Technical Service Information

THM 440-T4 NEW DESIGN OIL FILTER

Figure 1

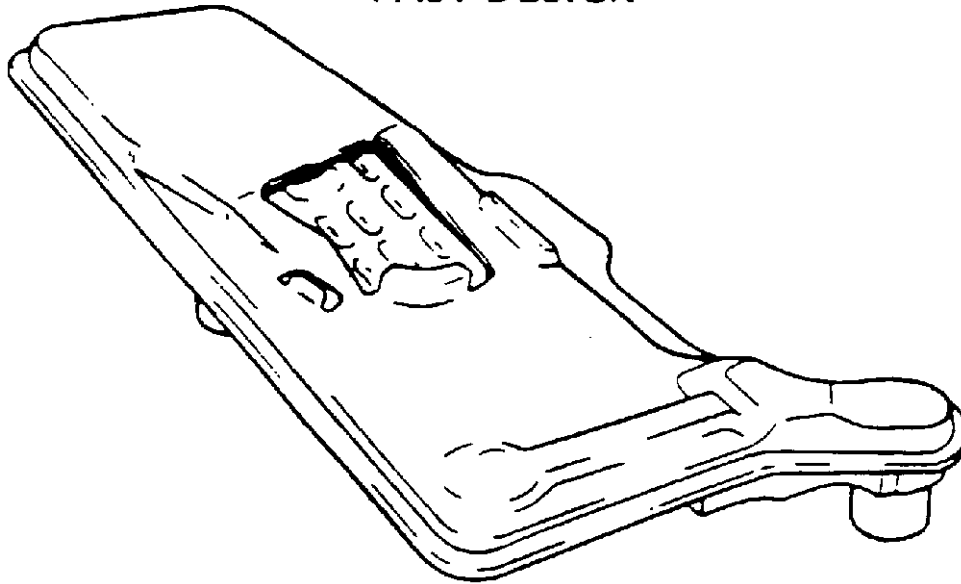
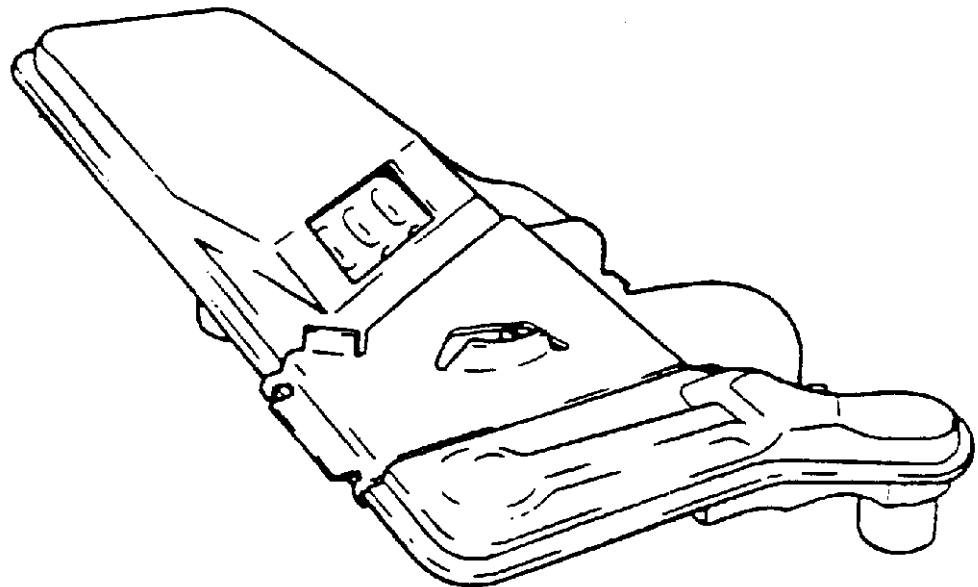
Engine flare, pump whine or transaxle slip during vehicle turns may be caused by low fluid level or the fluid filter.

Starting April 6, 1987 (Julian Date 096), all THM 440-T4 transaxles were built using a filter with a new inlet and baffle design.

Check for proper fluid level and correct as necessary. If the flare or whine still occurs remove the bottom pan and replace the filter and seal with a new filter (Figure 1) and seal package listed below in "Service Parts Information".

Oil pan gasket New fluid filter assembly (Figure 1)
